### Administrative Committee for the TIR Convention, 1975

#### Revision of the Convention:

Accepted amendment proposals to the  
Convention pending formal adoption

## Accepted amendment proposals to the Convention pending formal adoption

Sketch No. 9.4

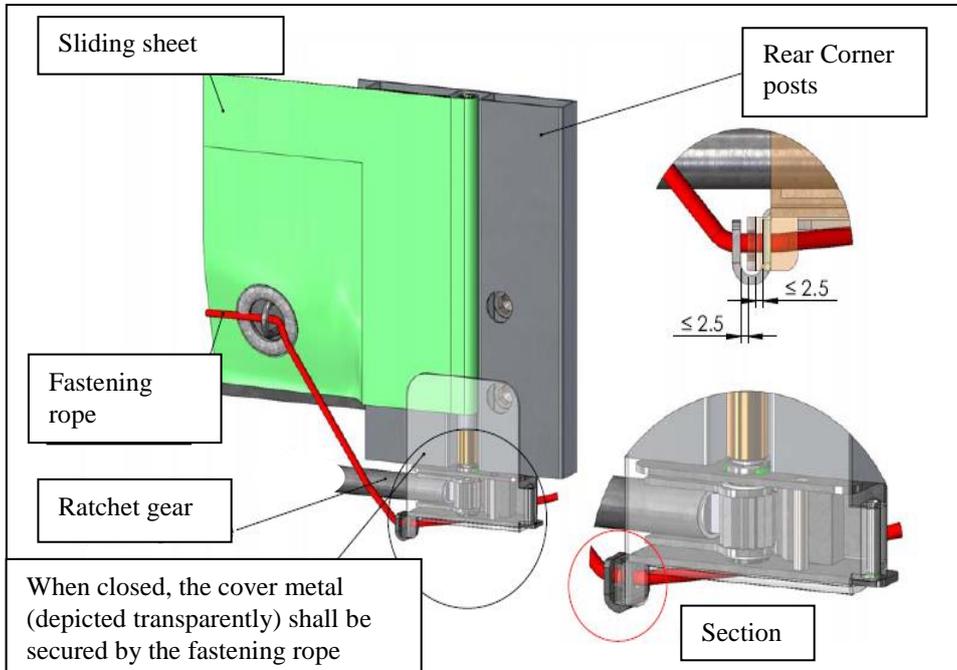
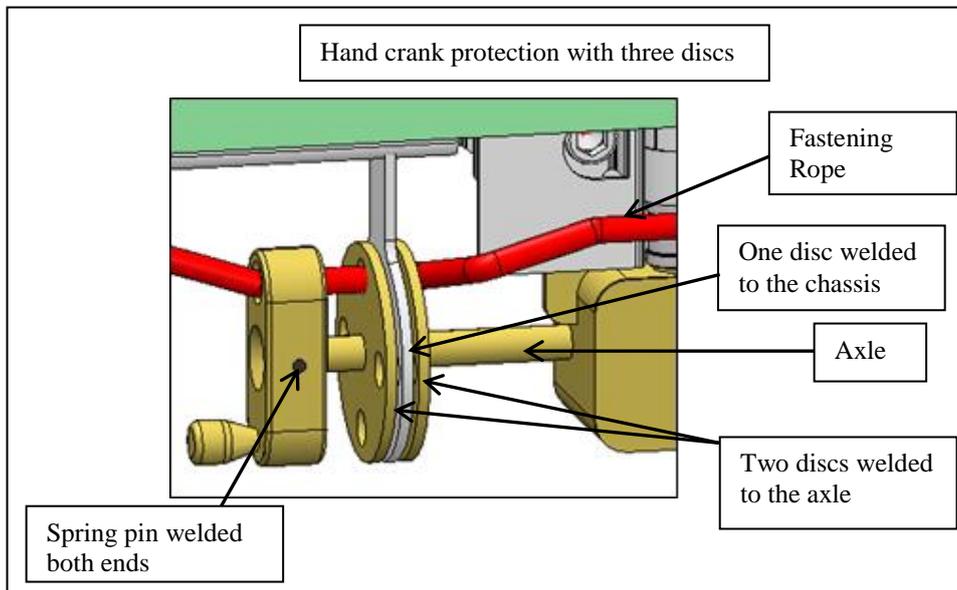
For the existing Sketch No. 9 *substitute*

To tighten the sliding sheets in the horizontal direction, a ratchet gear is used (normally at the rear end of the vehicle). This sketch shows two examples, (a) and (b), of how the ratchet or gearbox may be secured.

**Sketch No. 9.5**

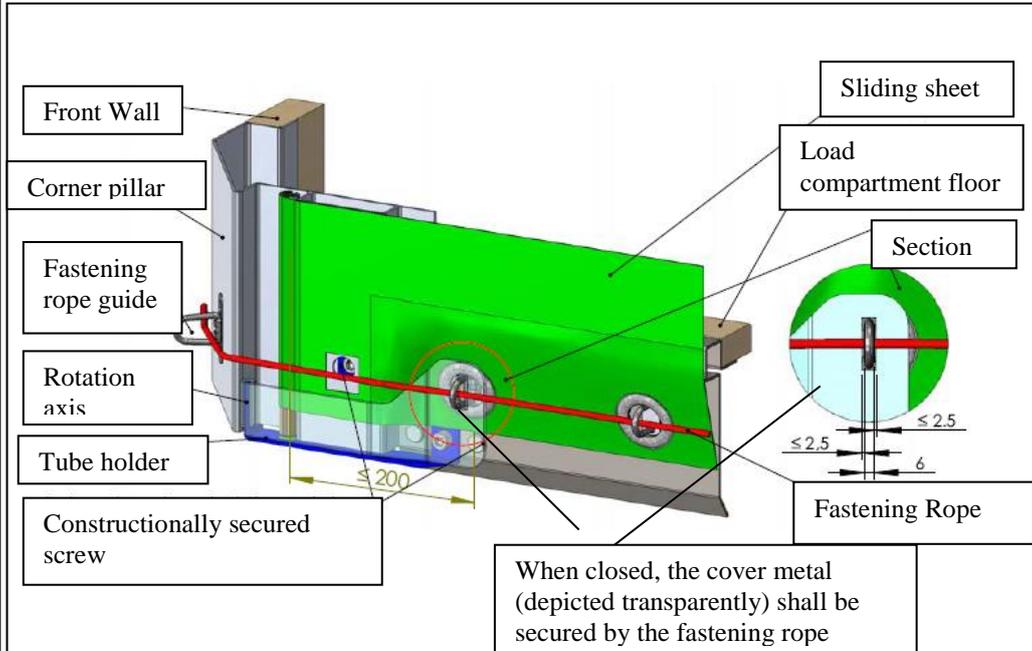
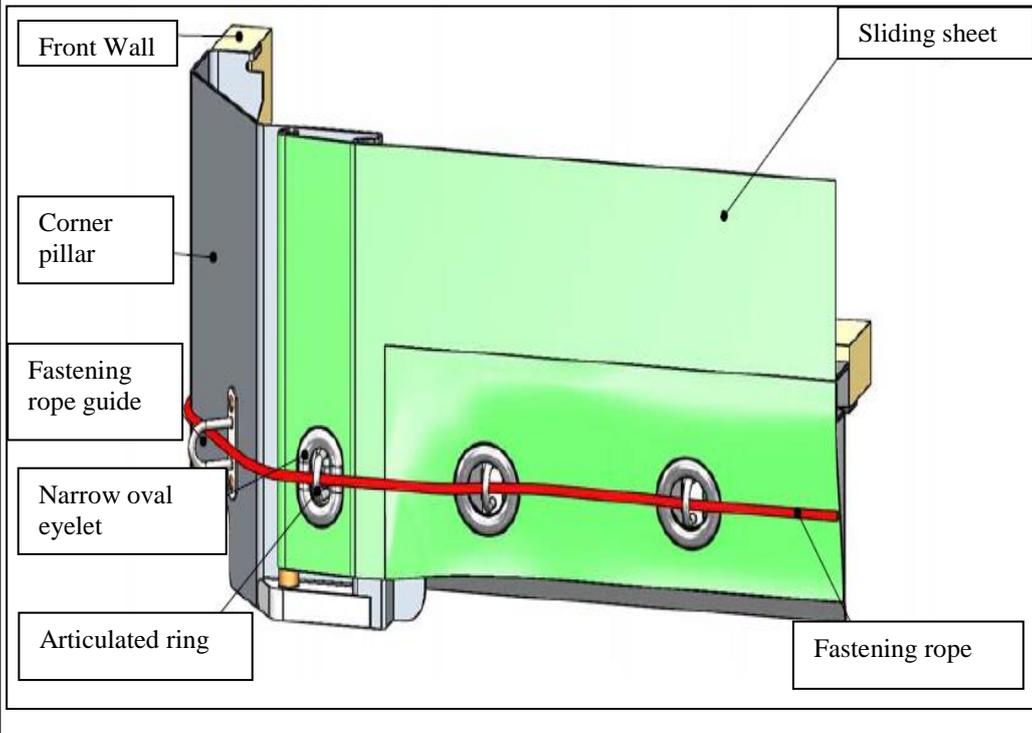
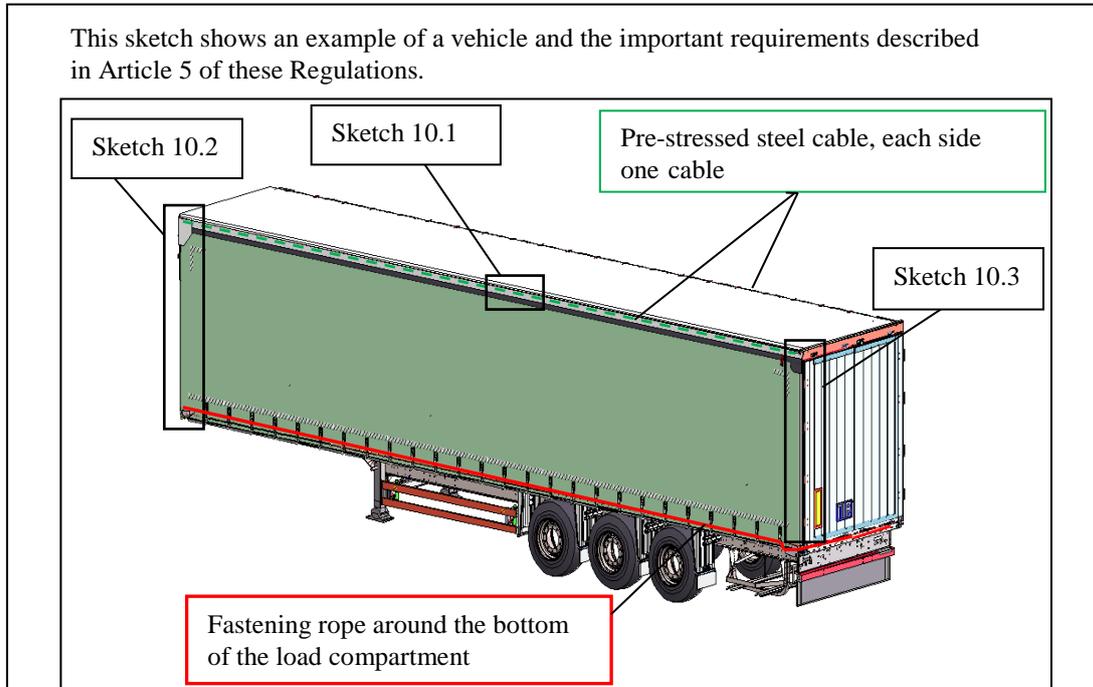
To fix the sliding sheet on the other side (normally the front of the vehicle), the following systems, (a) or (b), may be used.

**Annex 2, new Sketch No. 10***After new Sketch No. 9 insert*Sketch No. 10**EXAMPLE OF A CONSTRUCTION OF A VEHICLE WITH A SHEETED  
SLIDING ROOF**Sketch No. 10.1

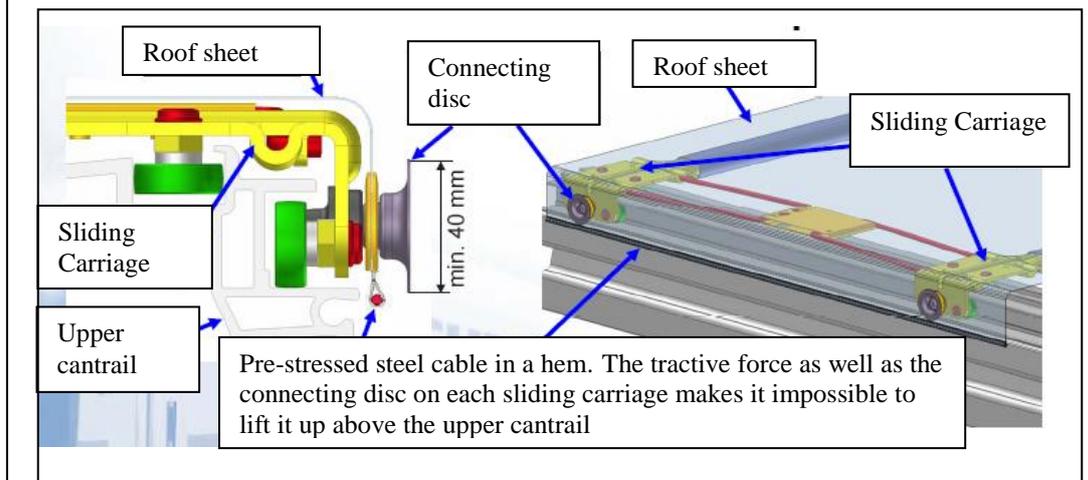
Two pre-stressed steel cables, embedded in a hem, are fixed on each side of the load compartment. This pre-stressed steel cable is fixed to the front (see sketch 10.2) and rear of the body (see sketch 10.3). The tractive force as well as the connecting disc on each sliding carriage makes it impossible to lift up the hem with the pre-stressed steel cable above the upper cantrail.

Sketch No.10.2

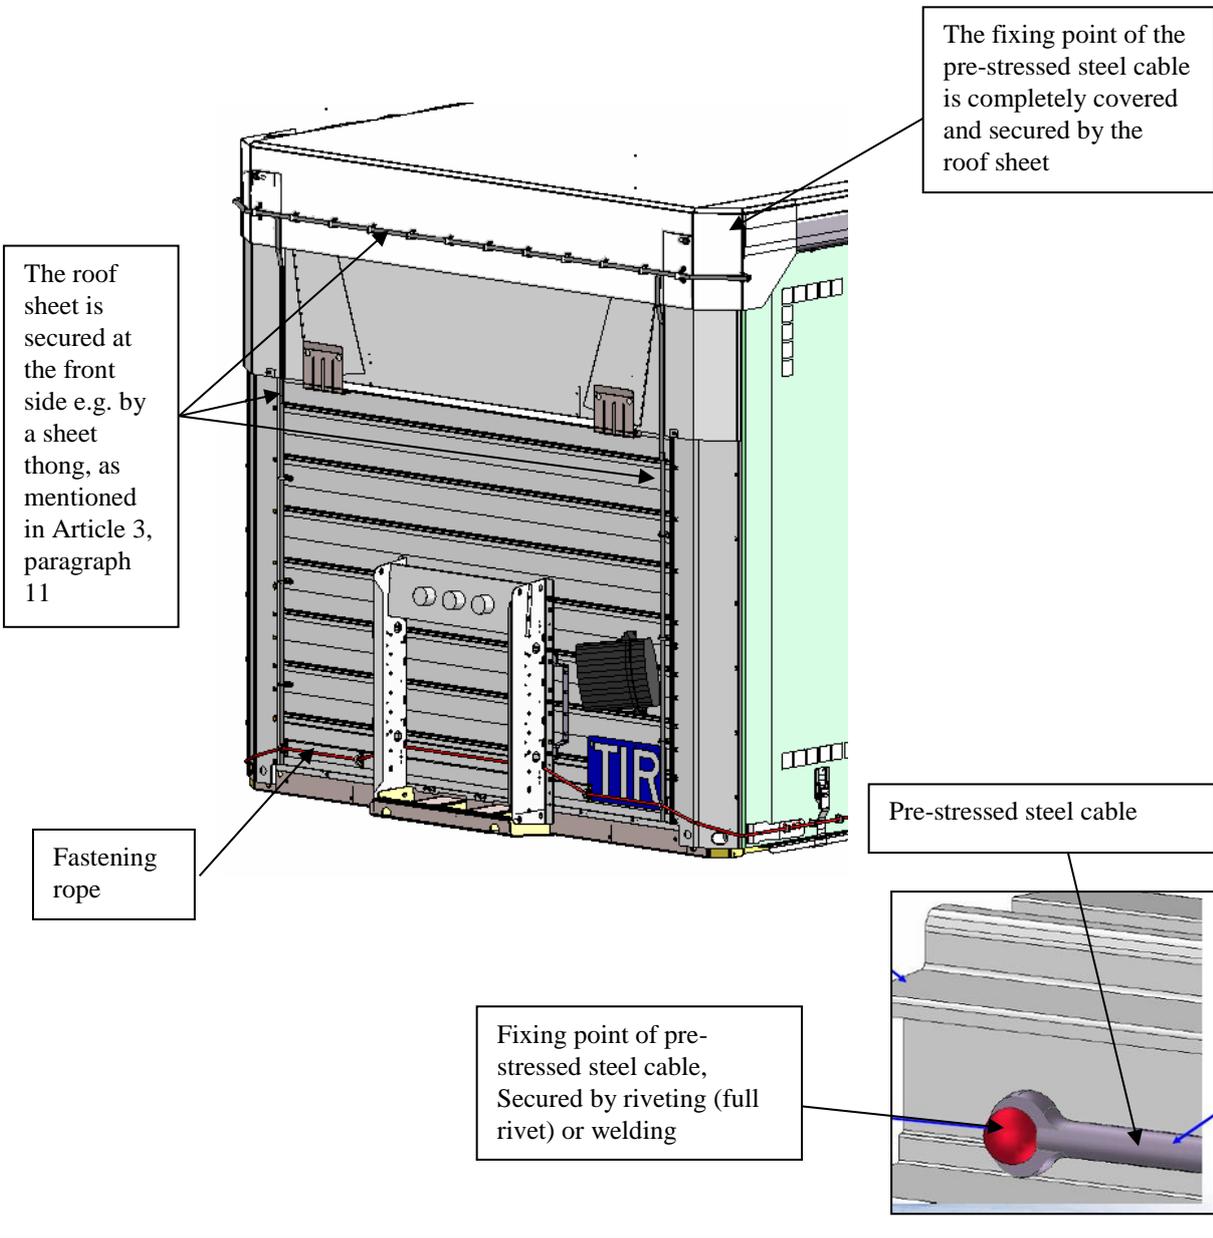
The sliding roof sheet shall overlap with the solid part of the roof at the front side of the load compartment, so that the roof sheet cannot be pulled over the top edge of the upper cantrail.

Sketch No.10.3

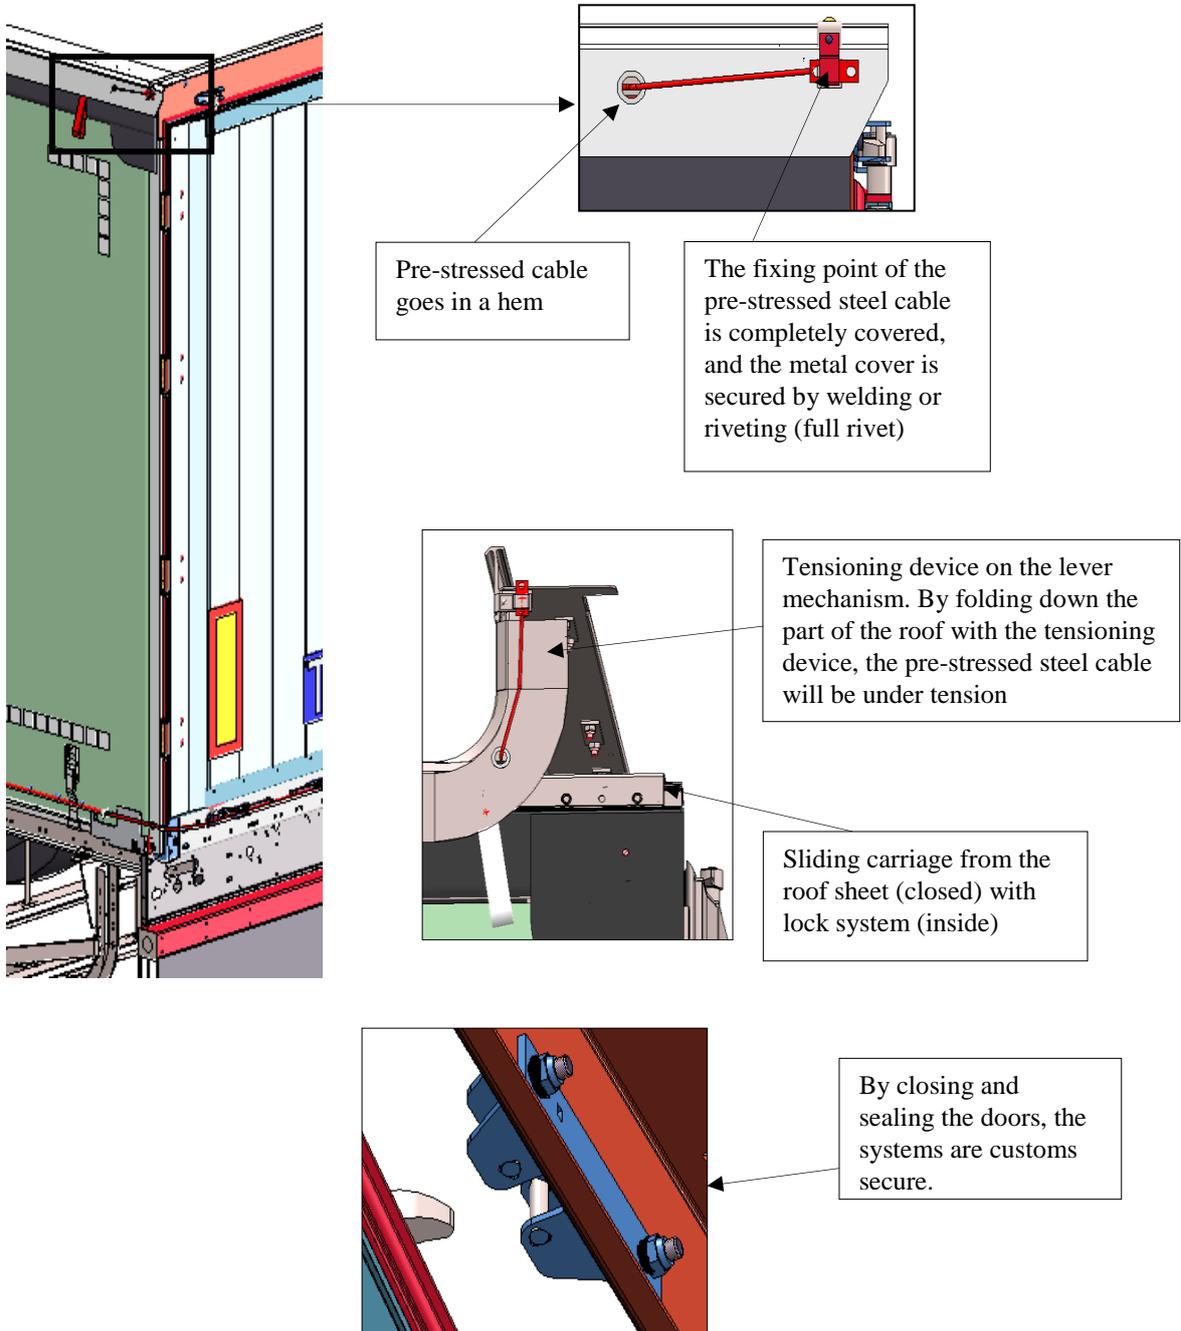
At the rear, a special device, such as a baffle plate, is fitted to the roof, preventing access to the load compartment, without leaving obvious traces when the doors are closed and sealed.

Sketch No. 9 continued

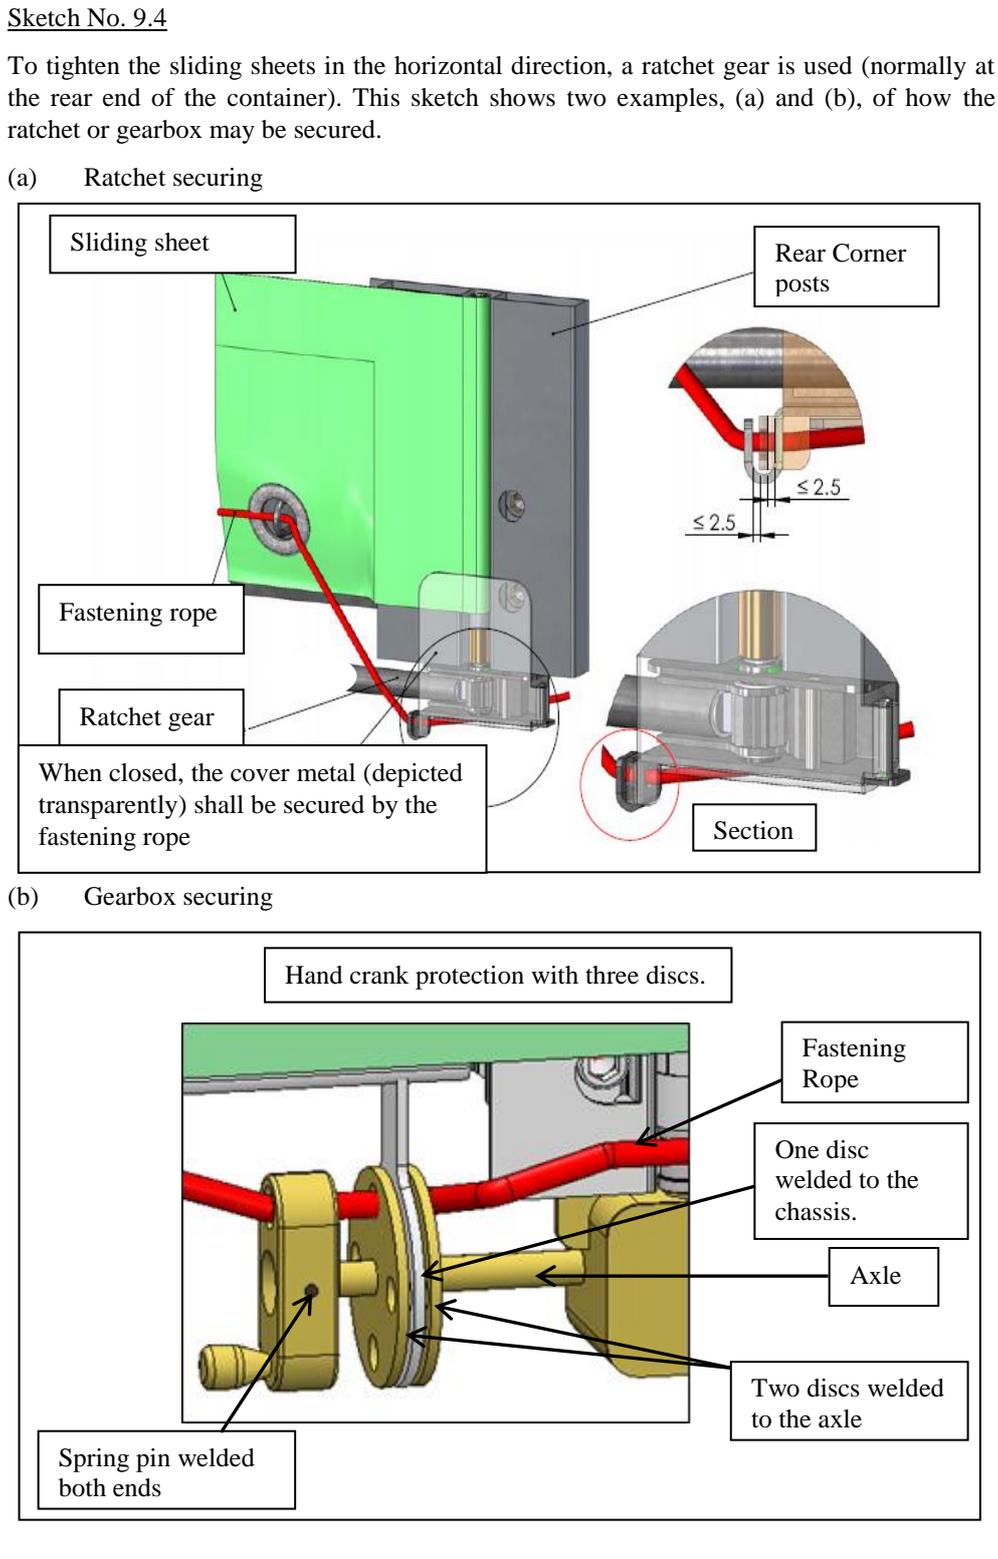
For the existing Sketch No. 9 substitute

**Sketch No. 9.5**

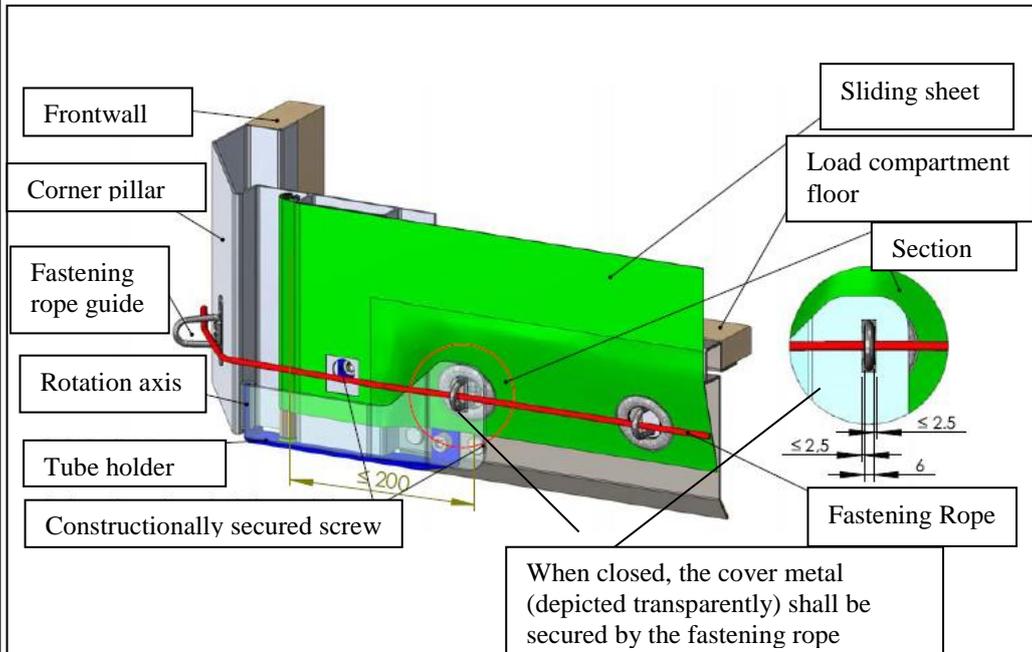
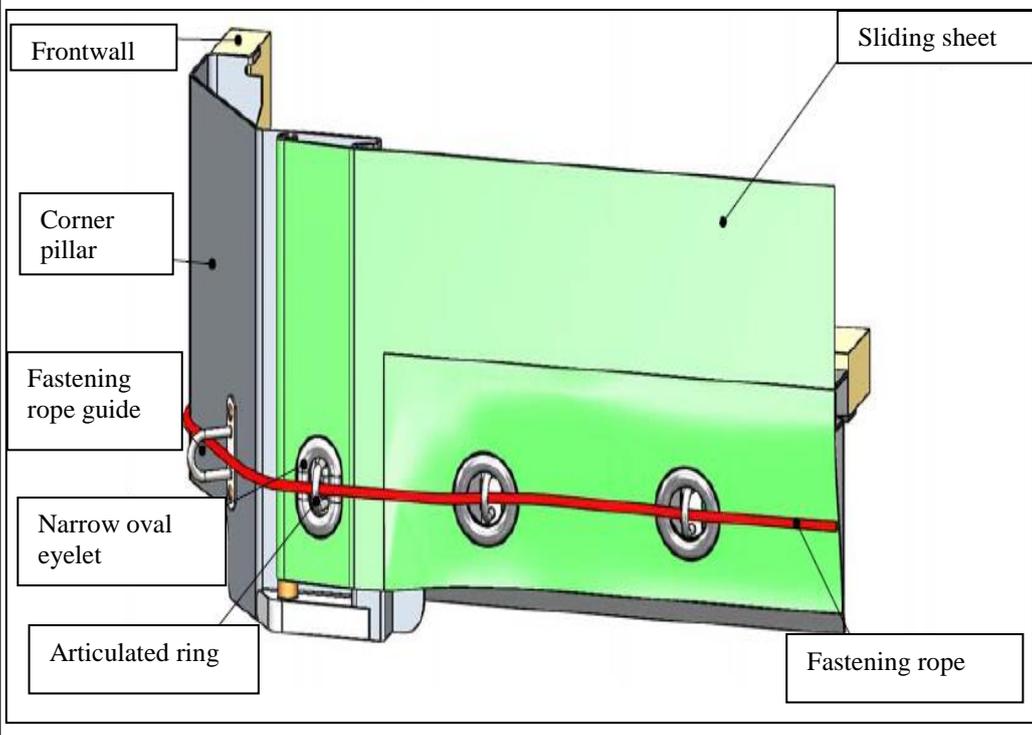
To fix the sliding sheet on the other side (normally the front of the container), the following systems, (a) or (b), may be used.

Sketch No. 10

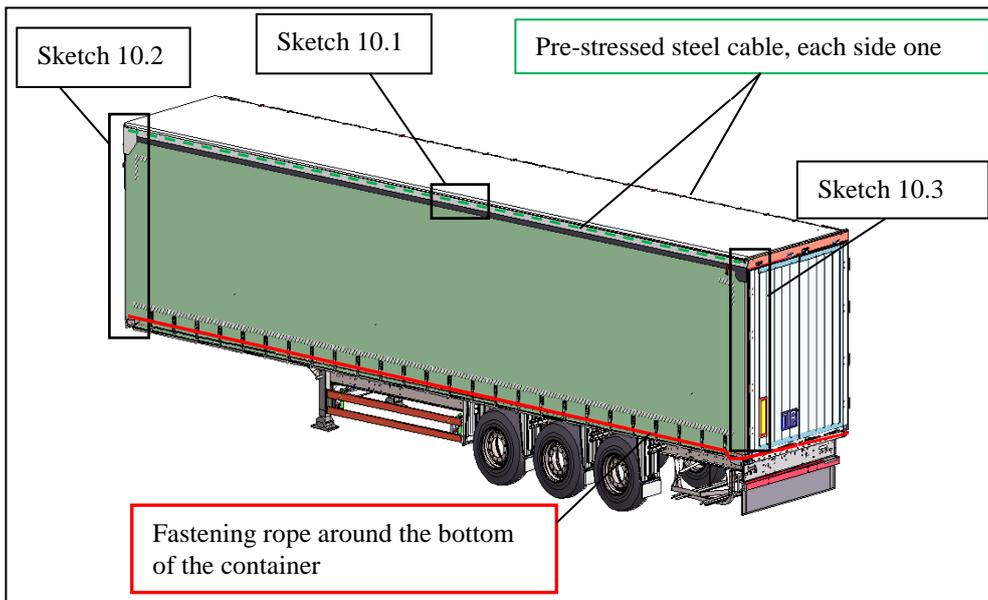
After new Sketch No. 9 insert

This sketch shows an example of a container and the important requirements described in Article 6 of these Regulations.

Sketch No. 10.1

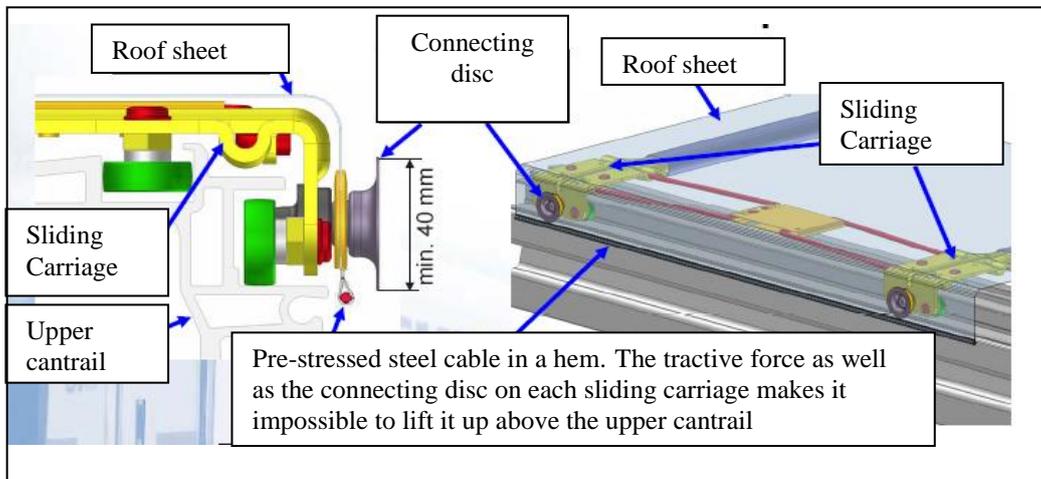
Two pre-stressed steel cables, embedded in a hem, are fixed on each side of the container. This pre-stressed steel cable is fixed to the front (see sketch 10.2) and rear of the body (see sketch 10.3). The tractive force as well as the connecting disc on each sliding carriage makes it impossible to lift up the hem with the pre-stressed steel cable above the upper cantrail.
